To:	All Plan Holders	Project:	Apron and Taxiway Reconstruction
Airport:	Dalhart Municipal Airport	KSA Project No.:	103412
Date:	Tuesday, May 12, 2026	TxDOT CSJ No.:	2604DHART

Addendum No. 1 Issued By:
KSA

DALHART MUNICIPAL AIRPORT DALHART, TEXAS APRON AND TAXIWAY RECONSTRUCTION PROJECT

ISSUED FOR BID ADDENDUM No. 1

A. Plan Sheet G01, Cover Sheet

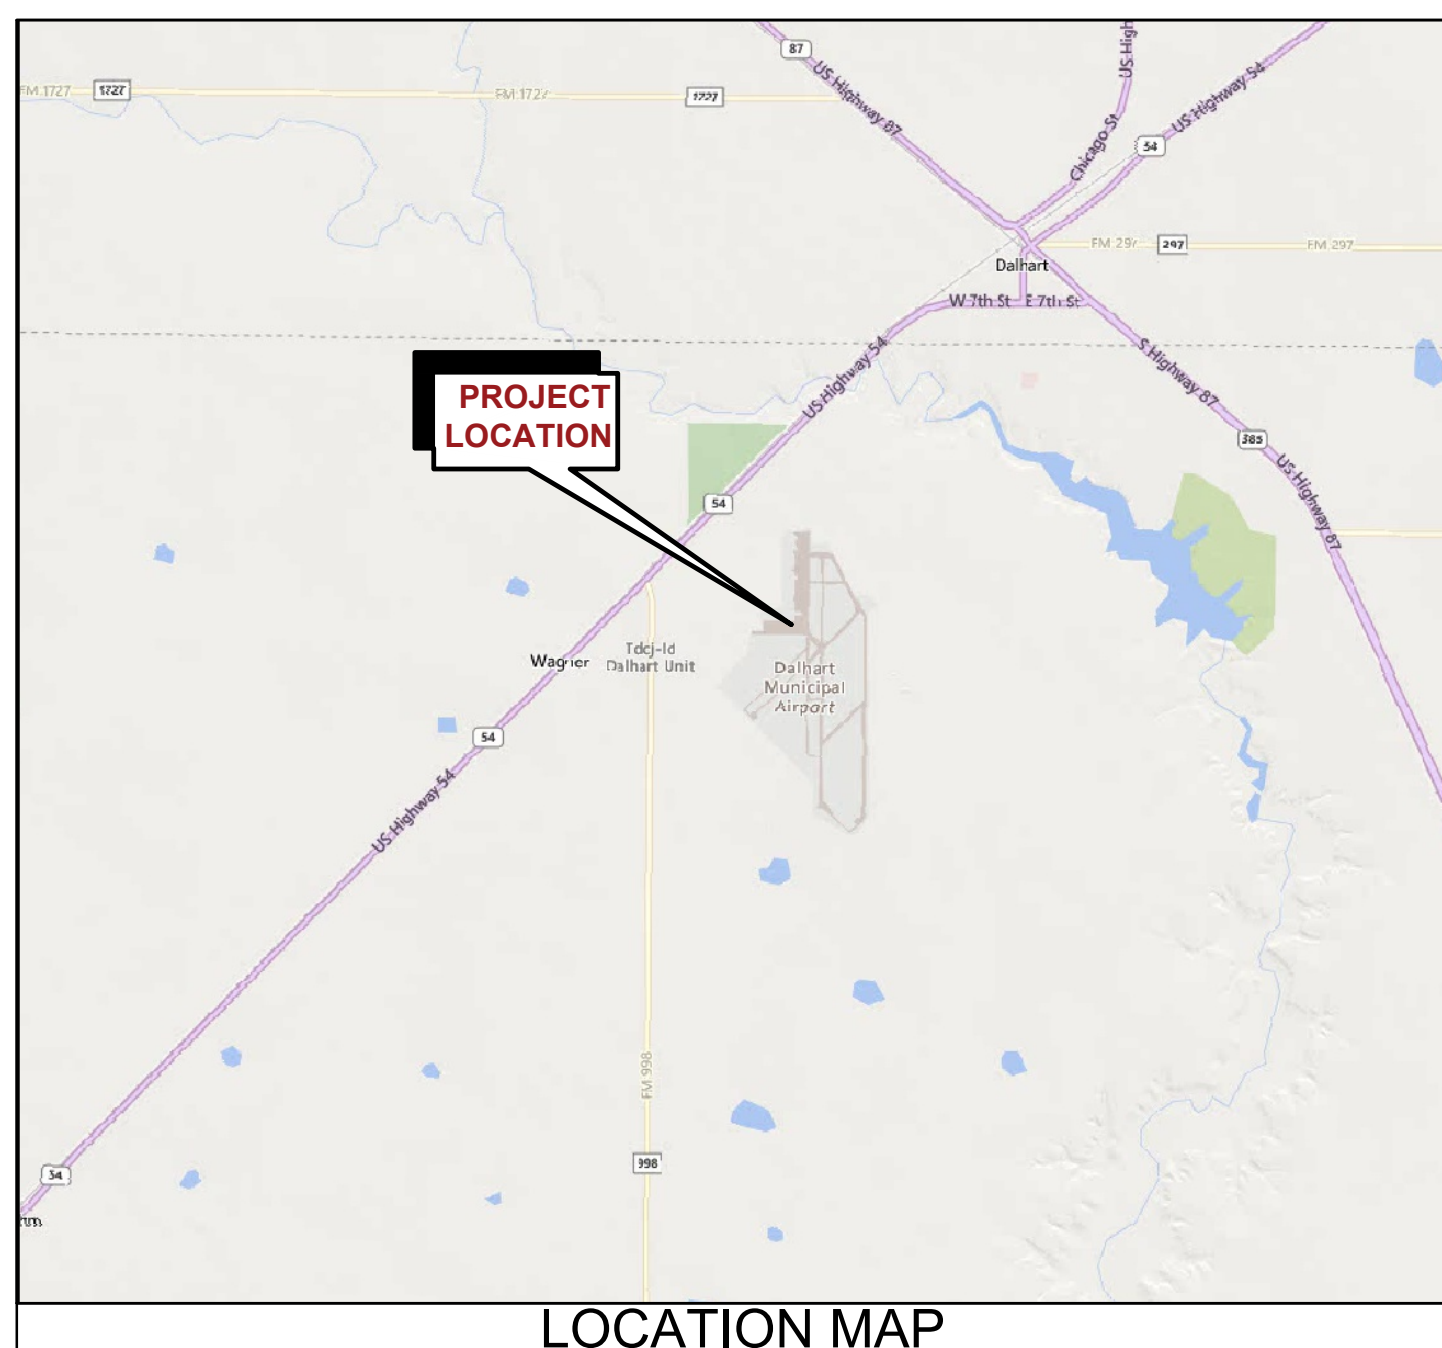
1. Added Taxiway Pavement Strength callout.

The taxiway pavement which is specified in this plan set for construction is designed to accommodate aircraft of gross weight (i.e. total takeoff weight) of 30,000 lbs or less.
